Ralston Avenue Belrose Planning Proposal: Review

Prepared for
RFS and Matthews Civil Pty Ltd

16 August 2017

Figure 3: Fire Spread from Mona Vale Road under FFDI 100

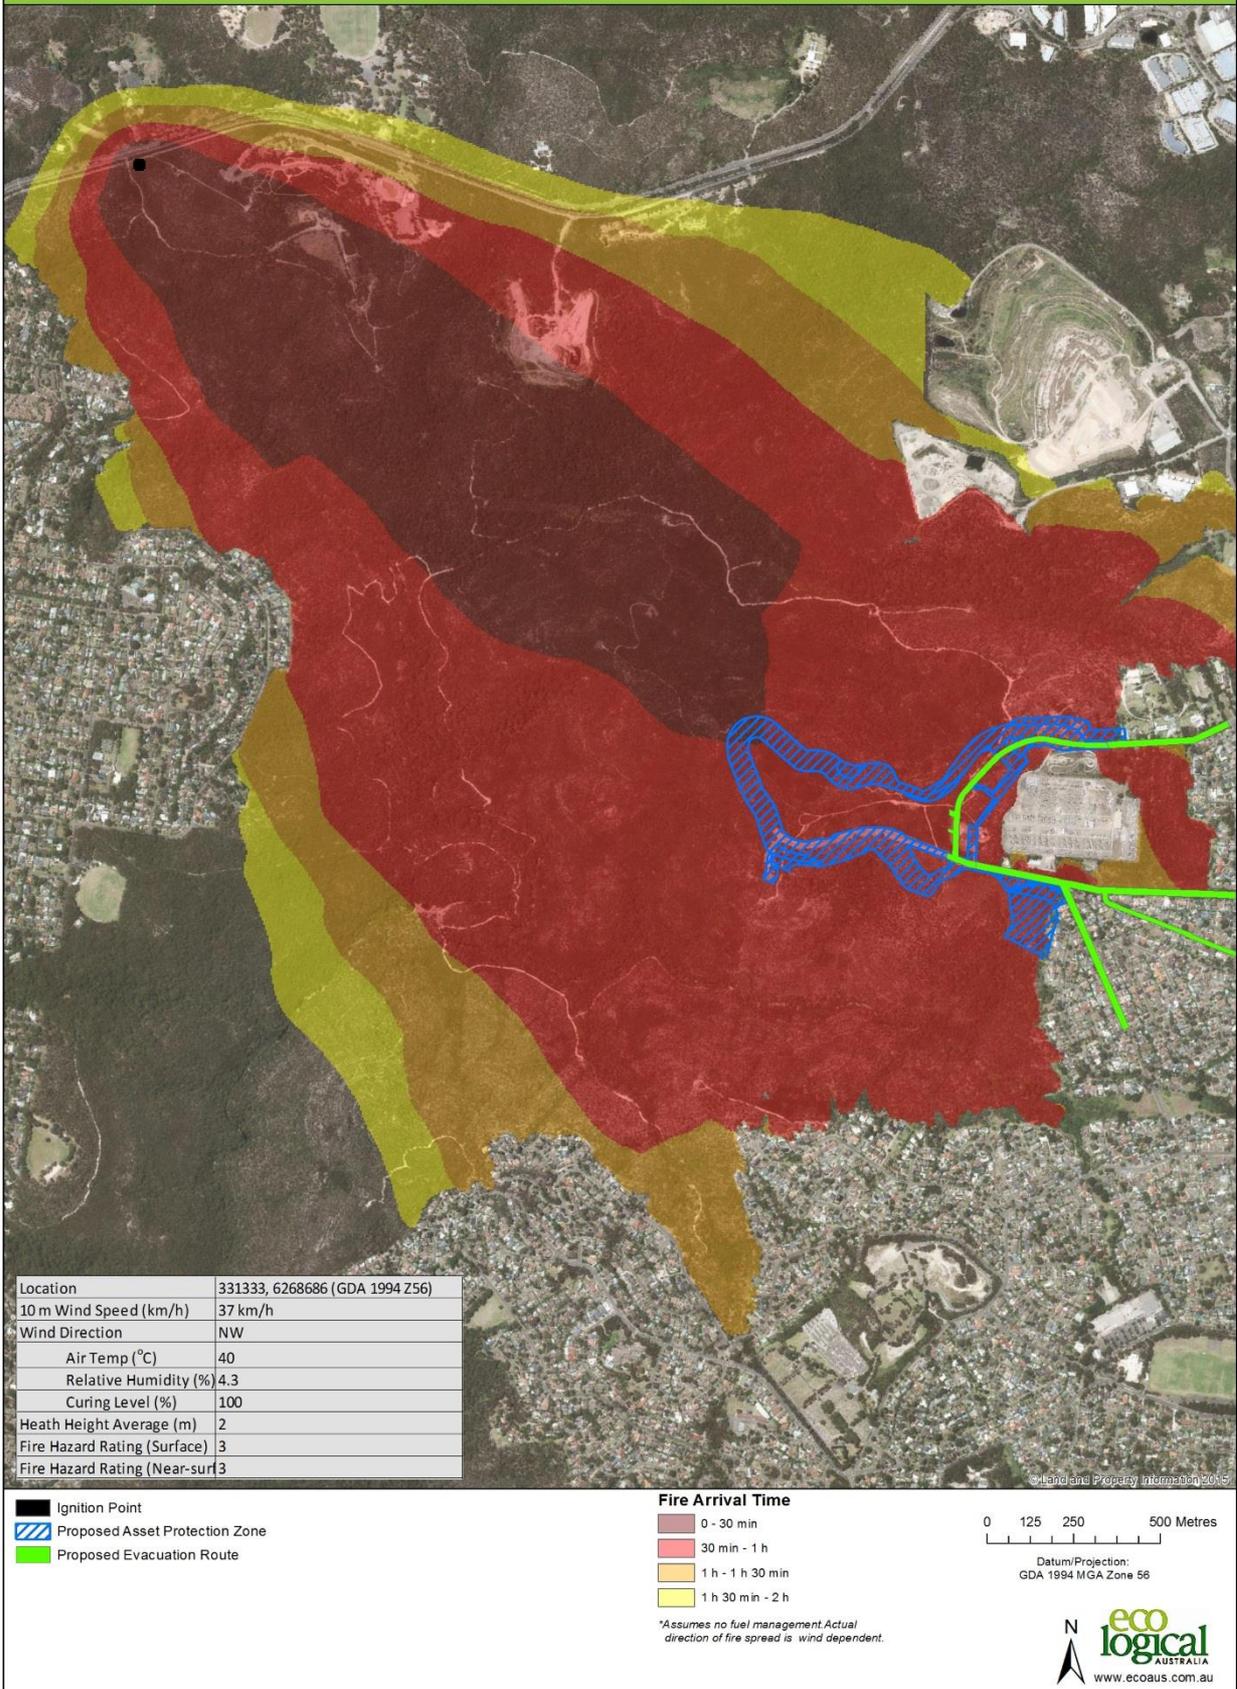
CSIRO's SPARK software has been used to calculate the travel time to impact the urban interface for two design fires (**Figure 3** and **4** shows these fires starting along Mona Vale Road). The fire arrival time is the time to reach the most north western part of the proposed development and the existing interface from ignition points of reasonable likelihood i.e. edge of a major road. As Planning for Bushfire Protection 2006 and most bushfire evacuation risk planning currently relies on offsite evacuation by multiple egress routes, the 'arrival time' for a bushfire attack under various weather events is a potential indicator of the feasibility of off-site evacuation.

Table 2 shows that under an FFDI 100 a fire from Mona Vale road would impact the proposed interface within 30 minutes and the existing interface within 42 minutes. These times are considered inadequate to safely and effectively evacuate either the existing or the proposed interfaces.

Figures 3 and 4 show an indicative fire progression under FFDI 100 and FFDI 55 where the fire attack will be so rapid that safe and effective evacuation from both the existing and proposed interface is not possible from a fire starting on or near Mona Vale Road.

Figure 4: Fire Spread from Mona Vale Road under FFDI 55

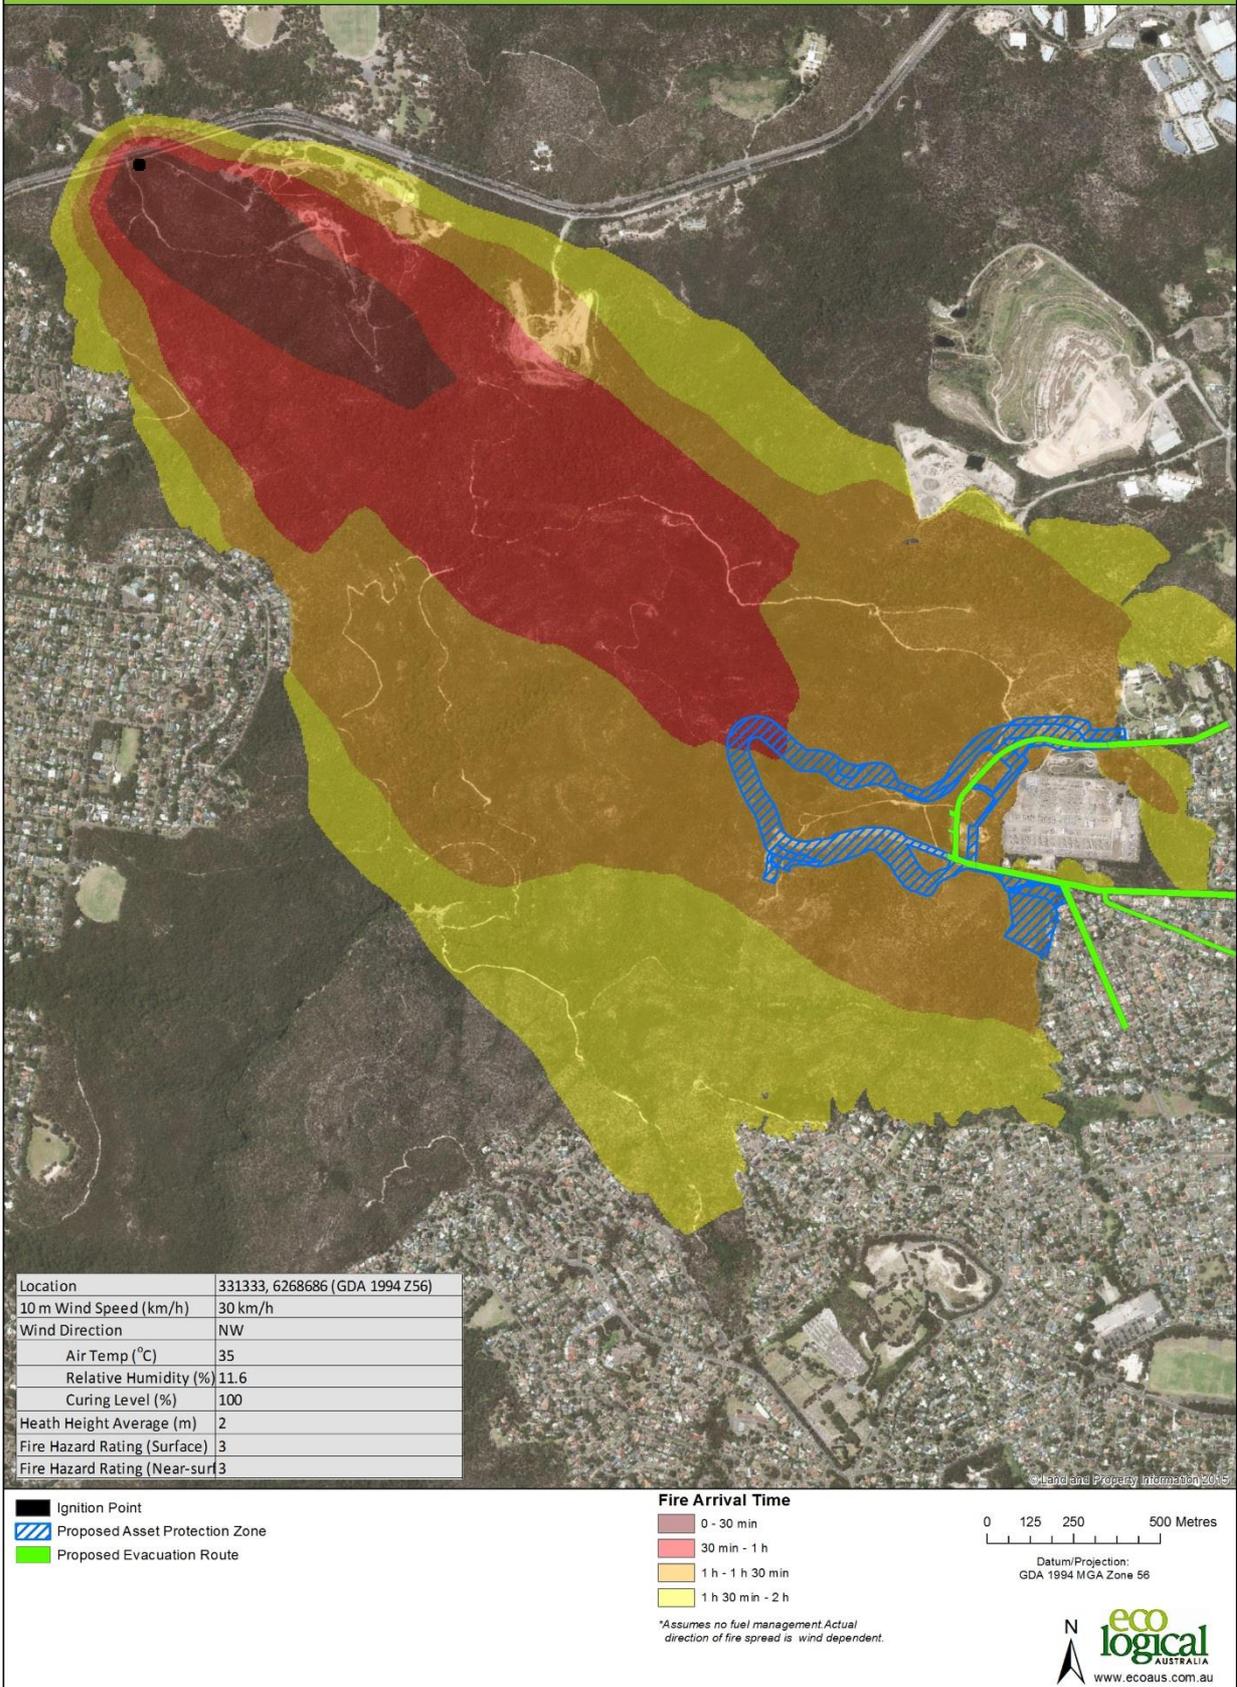
Table 3 shows that under an FFDI 55 (i.e. the FFDI value RFS previously used) a fire from Mona Vale road would impact the proposed interface within 57 minutes and the existing interface within 84 minutes. These are also inadequate times for early evacuation.
